# **WLTP-DHC Validation Phase I**

## **Results and Recommendations by India**

DHC Subgroup 10<sup>th</sup> Meeting - VTF Meeting  
11 – 13<sup>th</sup> Oct 2011, Brussels

# Japan Gear Shift \_ Alto

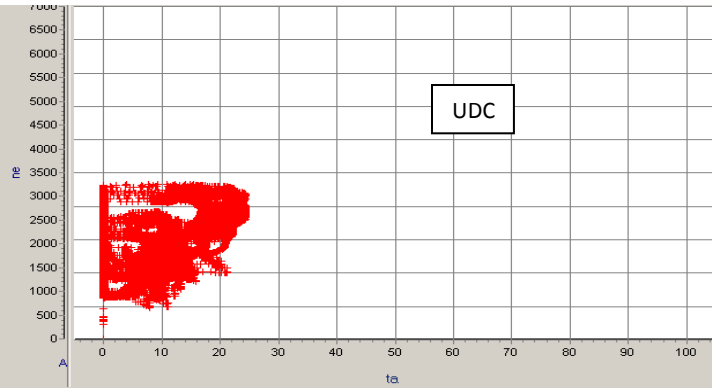
***It is difficult to meet target speed. Error is more than 10km/h in M and H Phases, even after driving vehicle in WOT.***

# Effect of Driving Cycle on Engine Operation\_Alto

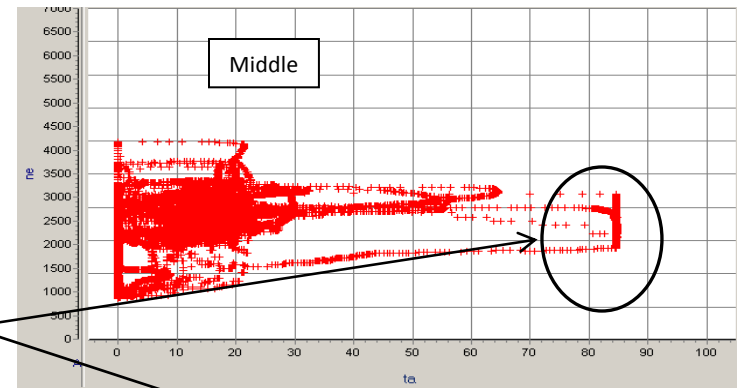
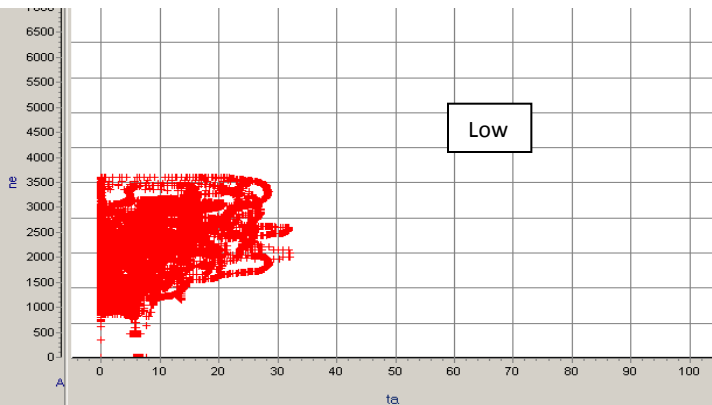
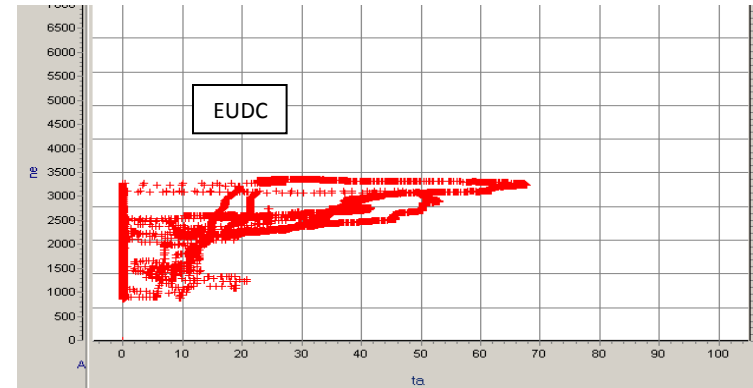
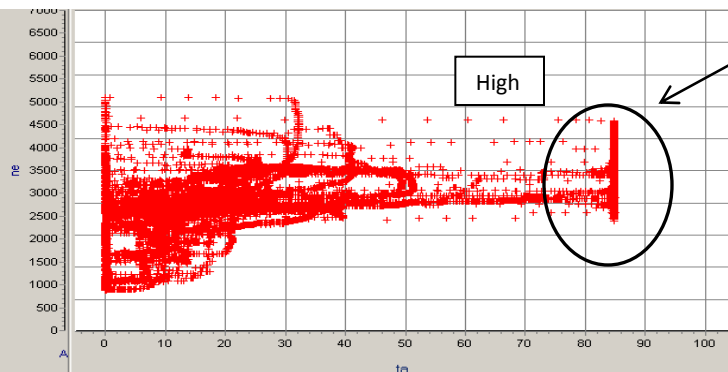
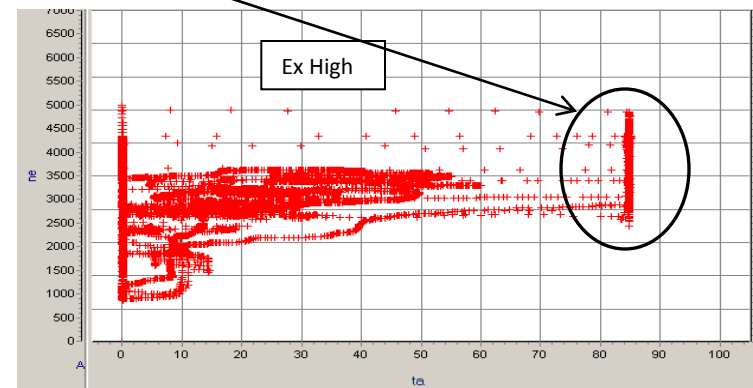
*Stringency of the  
new cycle is high on  
Small Cars esp. in M  
/ H Phases*

# Driving Cycle Max Speed (kmph)

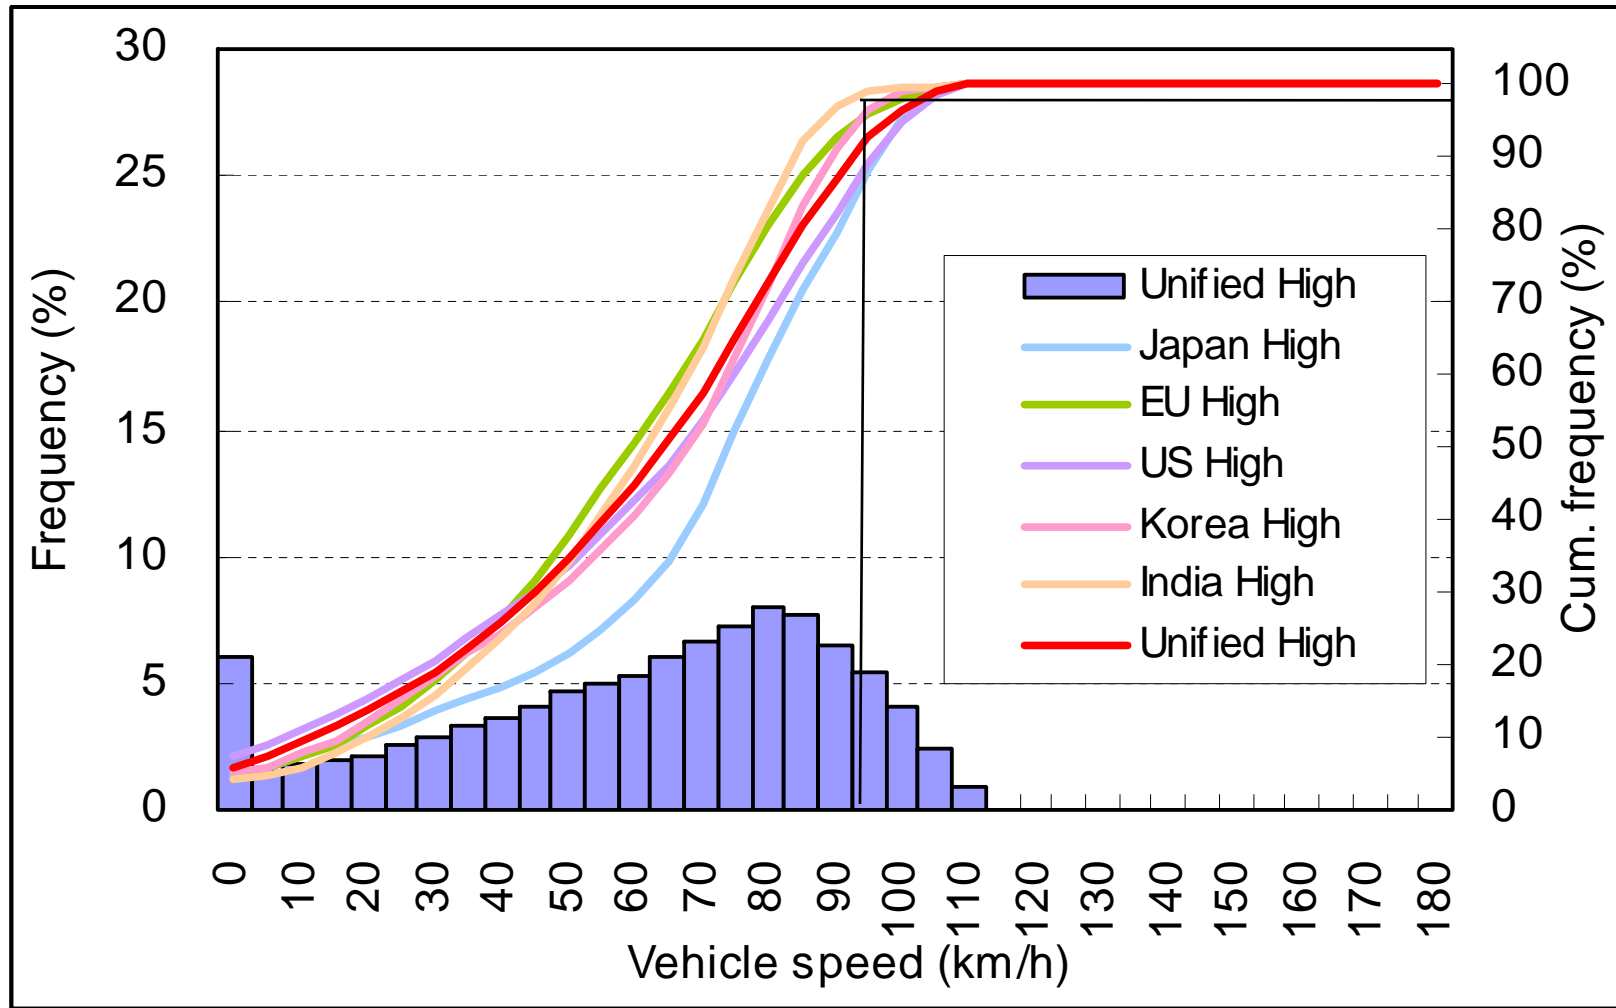
- ❑ WLTP Max Speeds are higher than current MIDC, NEDC, FTP & JP.
- ❑ Higher Max Speed and higher acceleration in WLTP, result in drivability issues in compact vehicles, esp. in which engine will be operating at full load and max engine speed.

***Based on Road Load Data submitted by CPs -  
Rationale of having the proposed Max Speed needs to be discussed.***

# WLTP Data: Speed Distribution (Extra-High Phase)

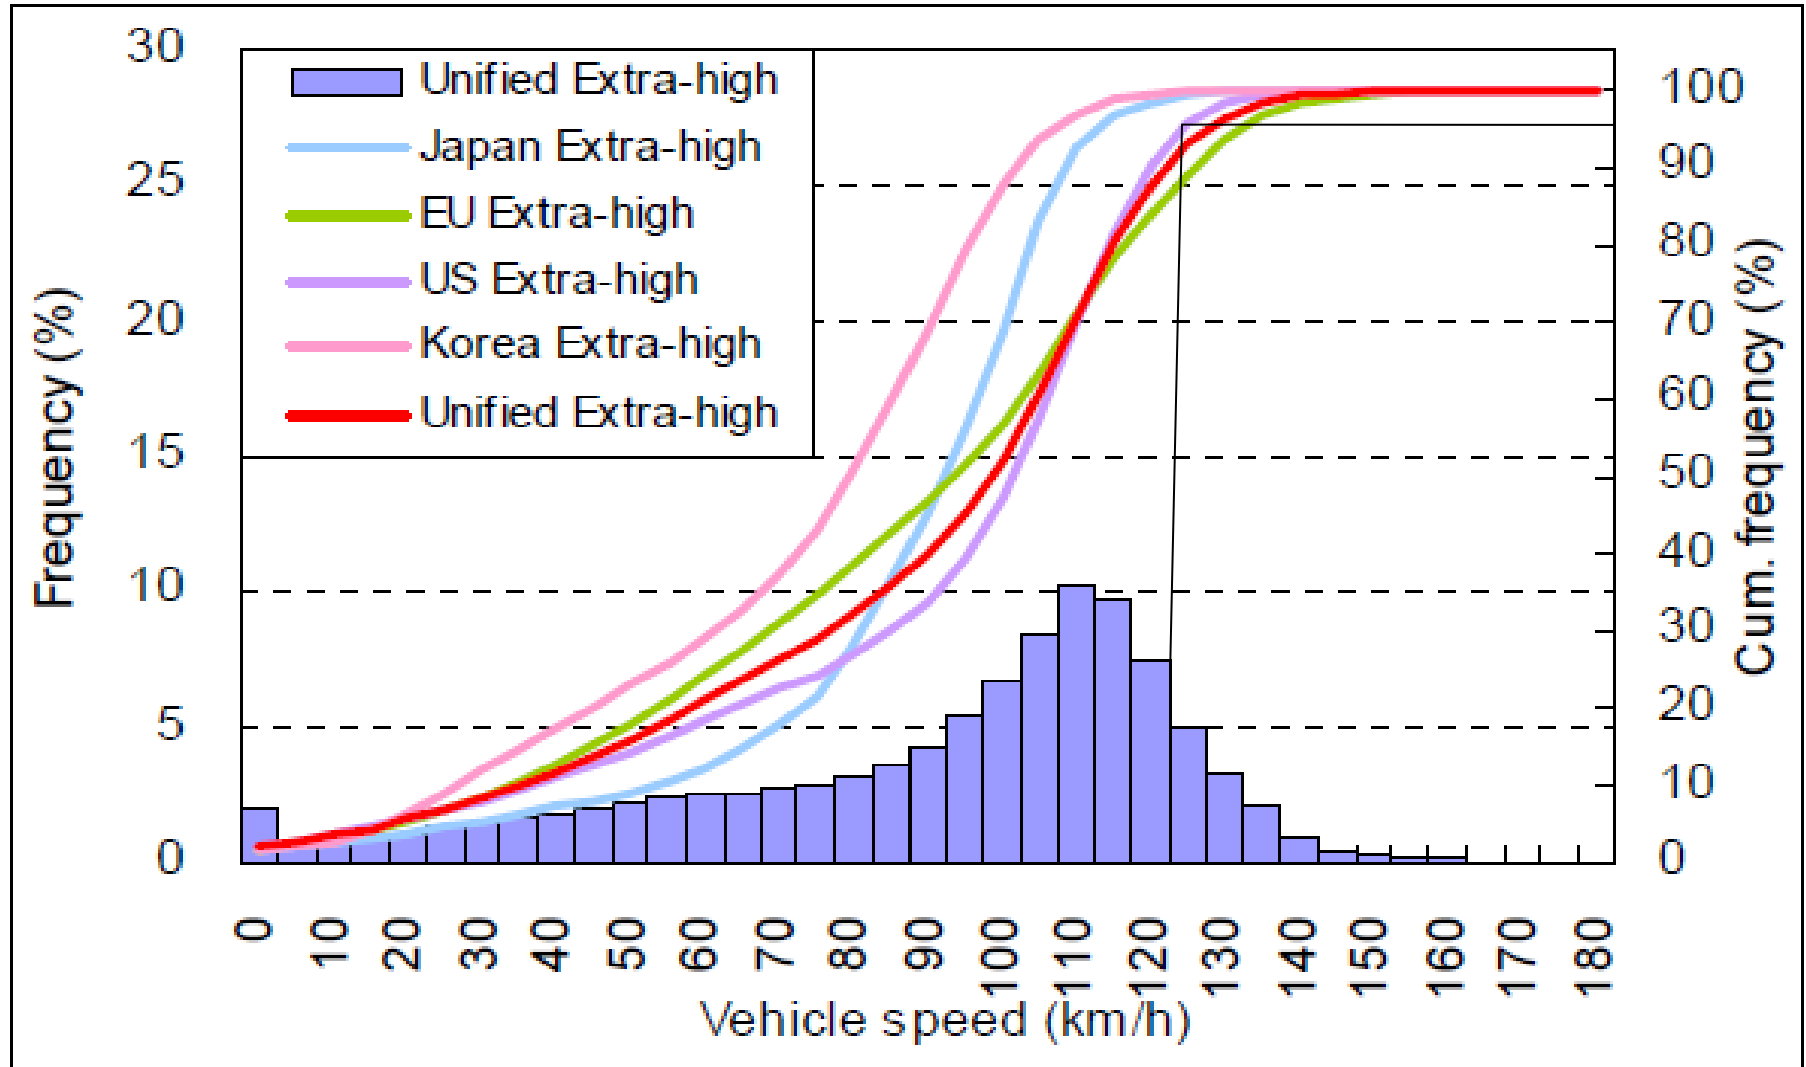
Analyzing the unified Extra-High Phase distribution, hardly 4% of the Driving Data exceeds 120km/h. There exists a strong rationale of lowering the max speed of the Extra High Phase to 120km/h.
